240-246 NORMANBY ROAD, SOUTH MELBOURNE

- 1.1 To provide a Council position for the Minister for Planning on an application to the Minister to prepare, adopt and approve an Amendment to the Port Phillip Planning Scheme under Section 20(4) of the Planning and Environment Act for 240-246 Normanby Road, South Melbourne.

| <b>APPLICATION NO:</b>                         | <b>DELWP Ref:</b> PA2015/35870 and PSA C195port<br><b>CoPP Ref:</b> 6/2015/MIN/A and PSA C195port  |

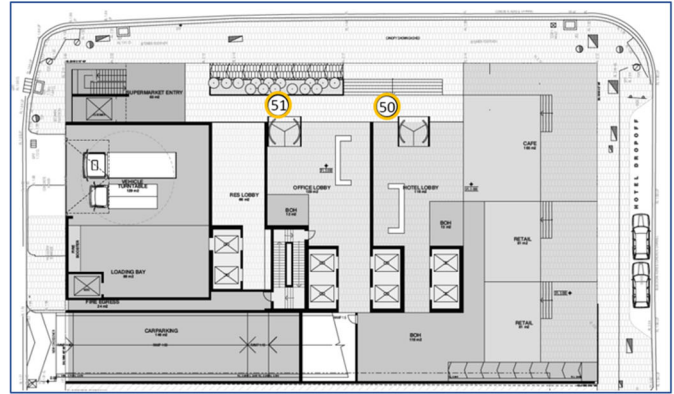
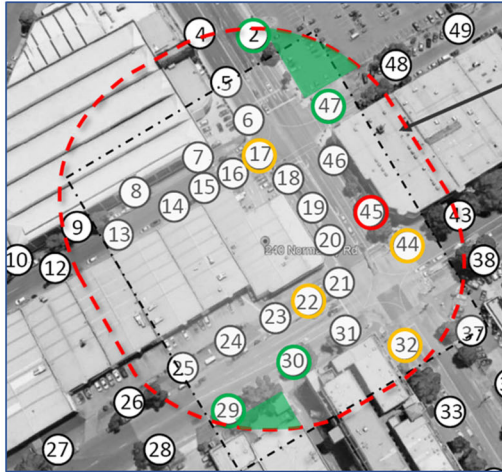
On this basis, adoption of walking comfort criteria for most publicly accessible areas is not supported, as this undermines the purpose of these areas.

An amended wind assessment is required that demonstrates compliance with the above planning requirements. Managing wind impacts on the public realm is closely associated with built form. Required wind treatments will need to be incorporated into the design of the development. On this basis, the wind assessment needs to be prepared, and the above matters addressed, prior to a decision being made. The amended wind assessment needs to address the following matters:

- The assessment distance used must be in accordance with Clause 2.11;
- The assessment must address approved and proposed development and publicly accessible areas within the assessment distance;
- The mandatory wind safety criteria in DDO33 must be achieved. Where the safety criterium is exceeded under existing conditions, the development must not increase the extent of non-compliance, and should seek to improve the level of safety;
- The following comfort criteria should apply to the publicly accessible areas within the assessment distance (not those recommended in the current wind assessment):

- Sitting – the future parks on the southern side of Normanby Road (close to Test Locations 29 & 30) and on the northern corner of Montague and Munro Streets (close to Test Locations 2 & 47) (shown as green in the diagram at left below). The current wind assessment does not include test locations within these proposed park locations, however, it is noted that Test Locations 2, 29, 30 and 47 do not meet the sitting comfort criteria as a result of the proposed building. Any proposed areas for outdoor seating in approved / proposed developments within the assessment distance also need to achieve this criteria;
